CITY PLAN COMMISSION STAFF REPORT

Project Name
Project Royal

CD-CPC-2022-00194
Development Plan

PROJECT ROYAL
KCMO DEVELOPMENT PLAN RE-SUBMISSION
DECEMBER 12, 2022

Overall Site Utility Plan

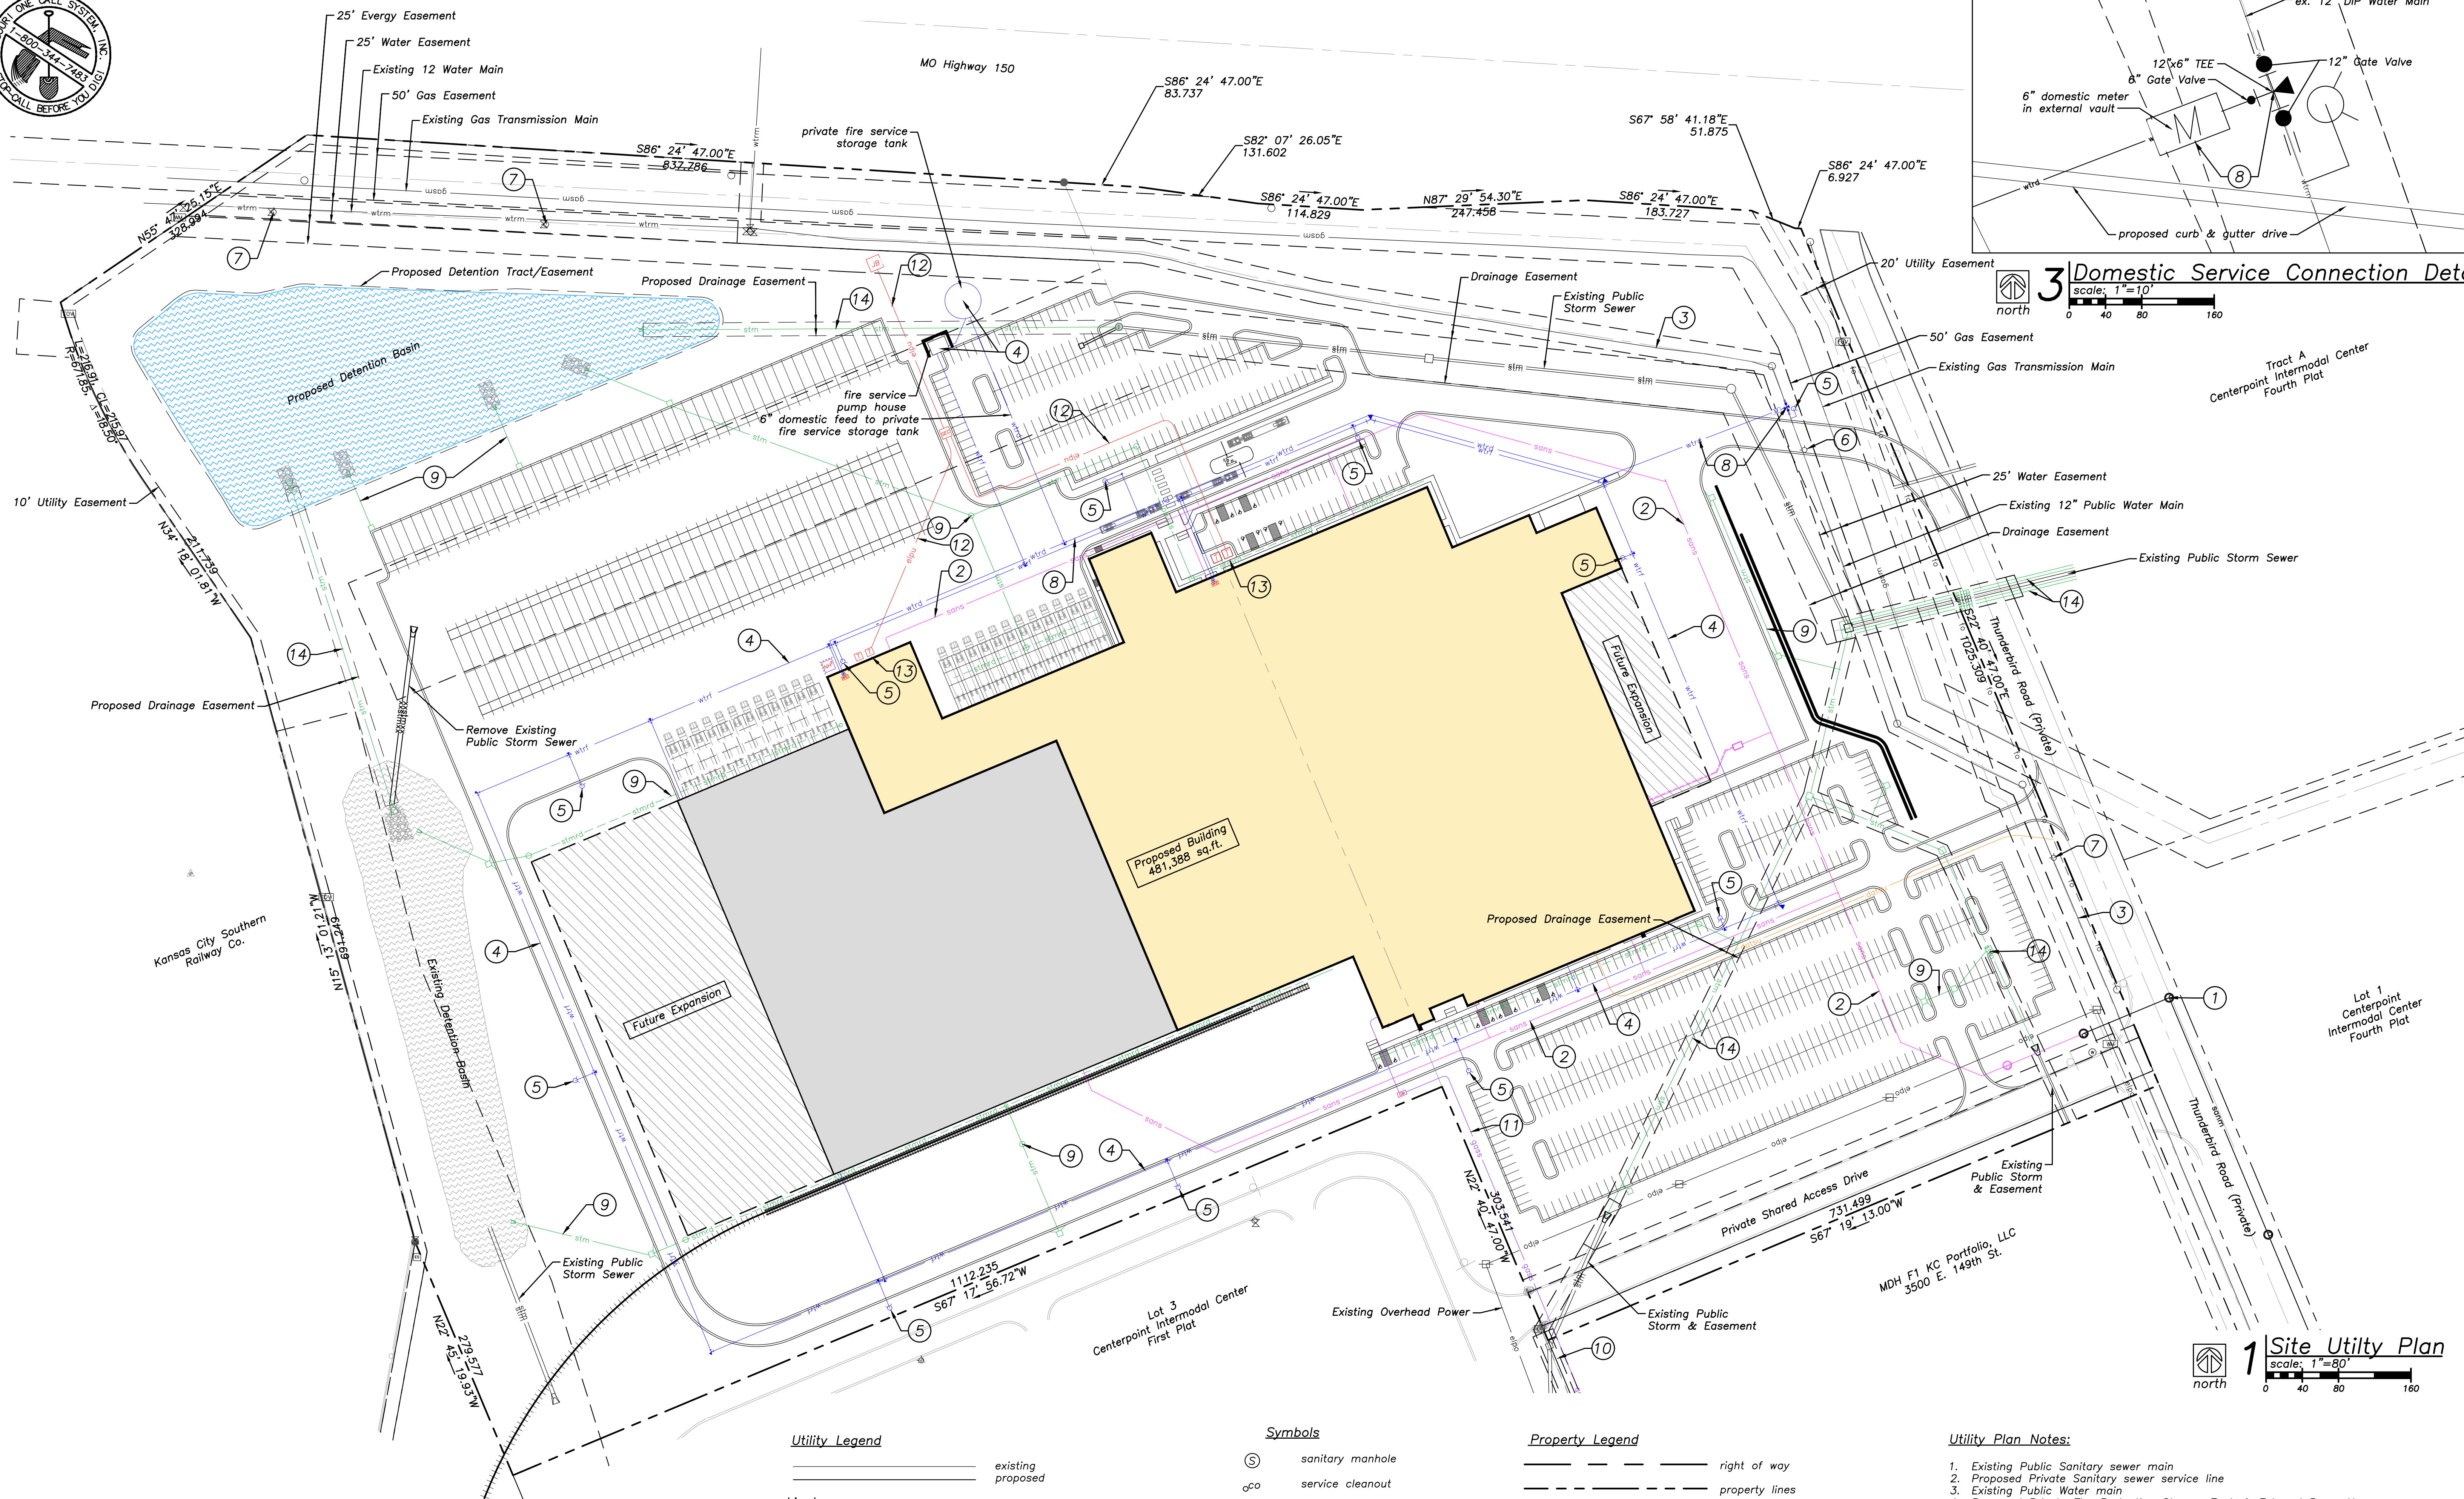
21. the max. domestic only water service shall be 1100 GPM through a maximum 6" domestic service without adding distribution system capacity with a water main extension.
22. The developer must submit Fire Hydrant relocation plans meeting the 300' maximum spacing along the adjacent public roadways. Plans shall be prepared by a registered professional Engineer in Missouri. They shall be submitted to the water main extension desk for review, acceptance and contracts per the KC Water Rules and Regulations for Water main extensions and Relocations.
(<https://www.kcwater.us/wp-content/uploads/2022/05/2022-Rules-and-Regulations-for-Water-Main-Extensions-Final2.pdf>
)

23. The developer provide acceptable easement, vacate existing easement, and secure permits to relocate sanitary sewers out from under proposed buildings and structures, etc., while continuing to ensure individual service is provided to all proposed lots as required by Land Development Division prior to recording the plat or issuance of a building permit, whichever occurs first.
